**6060B-04A-S**

**6060B - DC ELECTRONIC LOAD SINGLE-INPUT  
3-60 V. 0-60 A, 300 W DC**

**POSSIBLE “SHOCK PINCH” HAZARD**

**Due to poor soldering, the instrument’s internal safety grounding may be faulty.**

**“DEFECTIVE GROUND CONNECTION”**

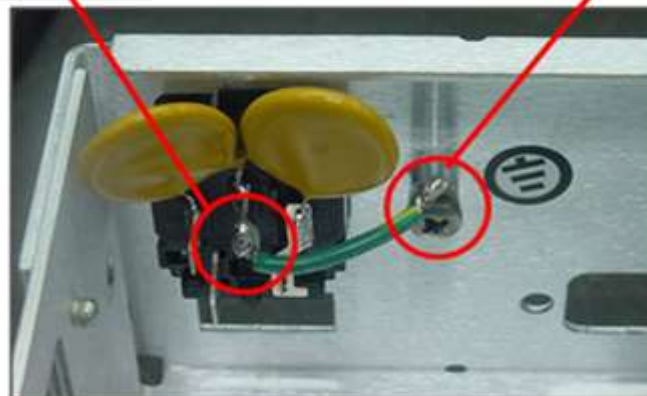
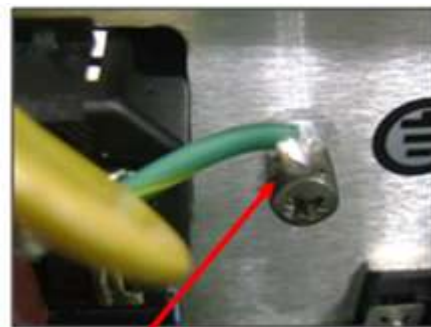
Refer to Figures “A” & “B” below. These figures are representative of insufficient solder connections at the ground pin of the AC INPUT MODULE and the instrument chassis ground.

If the Safety ground wire connections shown in Figures “A” & “B” do not meet or exceed acceptable solder connections as shown in Figure “C”, then the Safety ground connections must be repaired any person doing the repair must have the required knowledge to identify defective solder joints. It is also a requirement that the person doing the repair has the required skills to use hand tools and a soldering iron.

Figure “C”

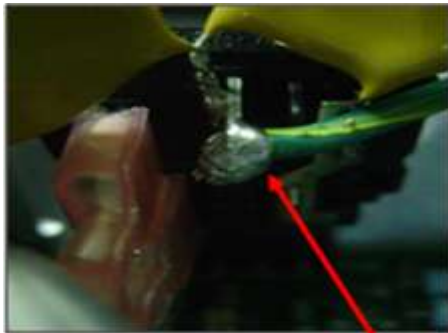
**“ACCEPTABLE GROUND CONNECTIONS”**
